NORTH MARSTON LANE

NEWMAN CLOSE

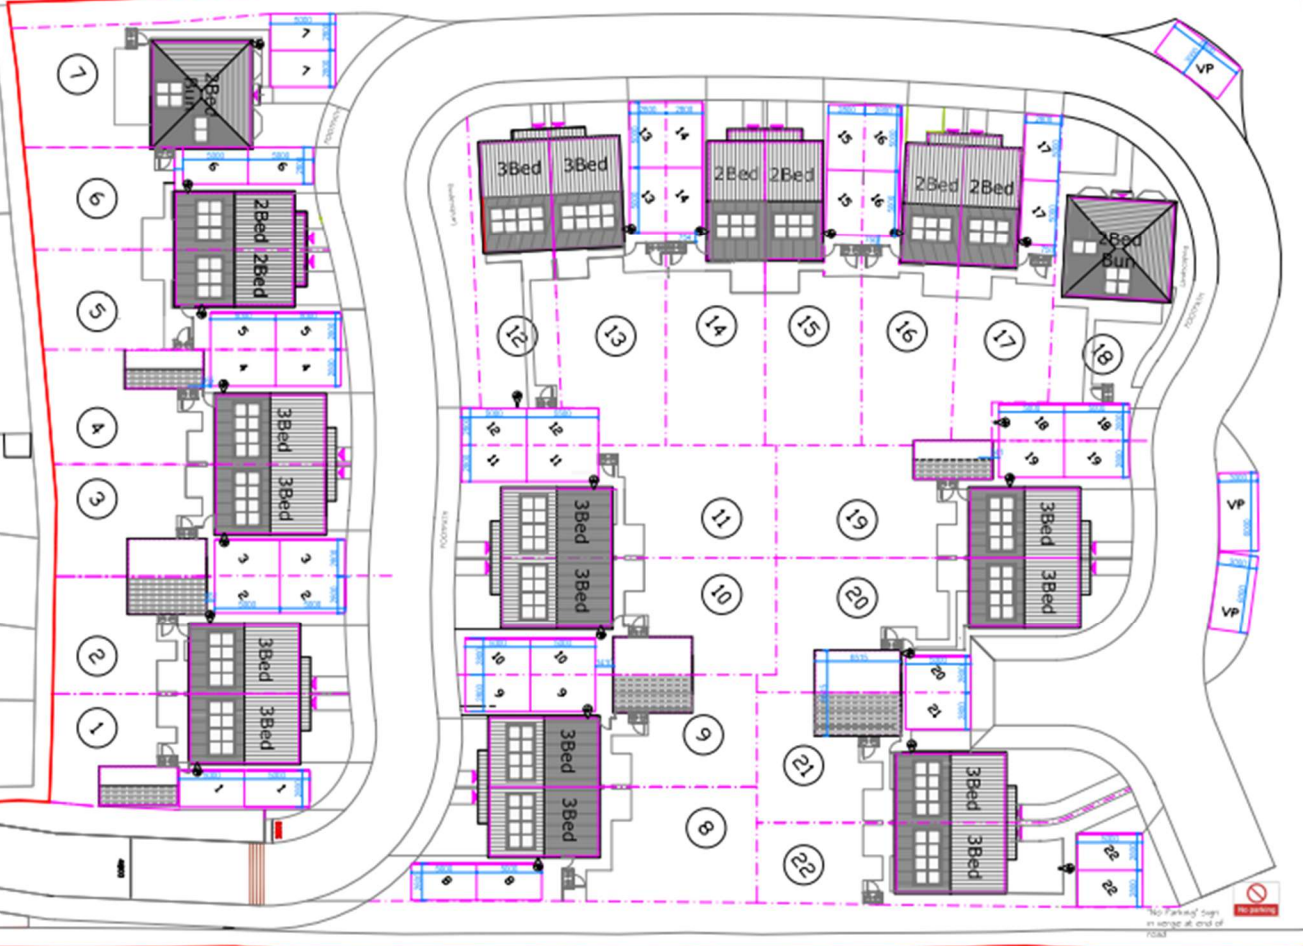
- REV E - Incorporating road layout recommended by transport advisors
- REV F - Waste Bin locations added
- REV G - Layout Amended
- REV H - Garages moved forwards. Where possible provide a gap (eg. 1metre) with a gate between the side elevation of the garage and the house.  
One turning head omitted as requested by planning.  
The footpath (previously added in accordance with the landscape officers previous advice) has now been removed at the request of the Planning Officer.

- REV I - Solar roof yards added.
- REV J - Size of car parking spaces plots 243, 8, 13-17 & 18 reduced as requested by Planning Officer. Garage to plot 8 omitted.

- REV K - Sizes of car parking spaces to properties amended to comply with revised changes to planning requirements. Visitor car parking spaces provided. Individual sizes of car parking spaces indicated. Garage openings plots 20 & 21 increased in size. Vehicle charging points added to each plot. Red line indicating side boundary amended. Driveway kept added to each adjacent side entrance. Side boundary revised to plots 7, 12 & 13, 17 & 18 and 214-222

- REV L - Location of 'No Parking' sign added
